Access Compliance Report

Public Rights-of-Way (Curb Ramps)

Intersection ID: 45891	Main Street: PROSPERITY_CHURCH_RD	Cross Street: STONE_PARK_DR	Location: SW
ADA ID: E27229311E77	Ramp Type: PerpDiag	Initial Pass/Fail: Fail	Overall Compliance: No
Severity Score: 8.75			
Codes/Mitigation Info/Possible Solution		Field Measurements/Component Compliance

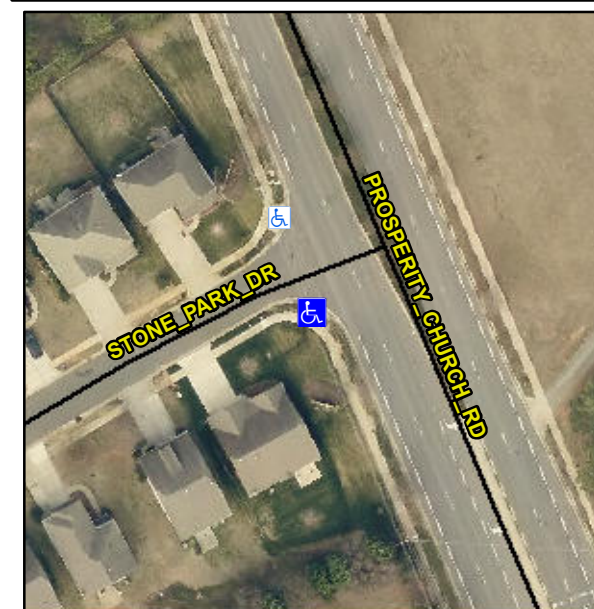
Not Found, R304.5.1

Compliance	Description	Data	Compliance	Description	Data
N/A	Ramp Length (in)	72.5	Yes	Ramp Slope (%)	7.7
No	Ramp Width (in)	36.5	Yes	Ramp XSlope (%)	1.3
N/A	Flare Type LT	N/A	N/A	Flare Type RT	N/A
N/A	Flare Slope LT (%)	N/A	N/A	Flare Slope RT (%)	N/A
N/A	Flare Traversable LT?	N/A	N/A	Flare Traversable RT?	N/A
N/A	Landing Length (in)	N/A	N/A	DWS Provided?	N/A
N/A	Landing Width (in)	N/A	N/A	DWS Contrast?	N/A
N/A	Landing Slope (%)	N/A	N/A	DWS Length (in)	N/A
N/A	Landing X Slope (%)	N/A	N/A	DWS Full Width?	N/A
N/A	Landing Curb? (Y/N)	N/A	N/A	DWS Offset (in)	N/A
N/A	Shared Landing?	N/A			
N/A	Gutter Ponding?	N/A	N/A	Gutter Slope (%)	N/A
N/A	Gutter Lip Ht (in)	N/A	N/A	Gutter X Slope (%)	N/A
N/A	Painted X Walk1?	No	N/A	Painted X Walk2?	No
	X Walk 1 Direction	To E		X Walk 2 Direction	To N
N/A	X Walk 1 Width (in)	N/A	N/A	X Walk 2 Width (in)	N/A
	X Walk 1 Slope (%)	2.0		X Walk 2 Slope (%)	1.7
	X Walk 1 X Slope (%)	1.3		X Walk 2 X Slope (%)	1.3

Remove & Replace Curb Ramp With Two New Directional Ramps or Equivalent.
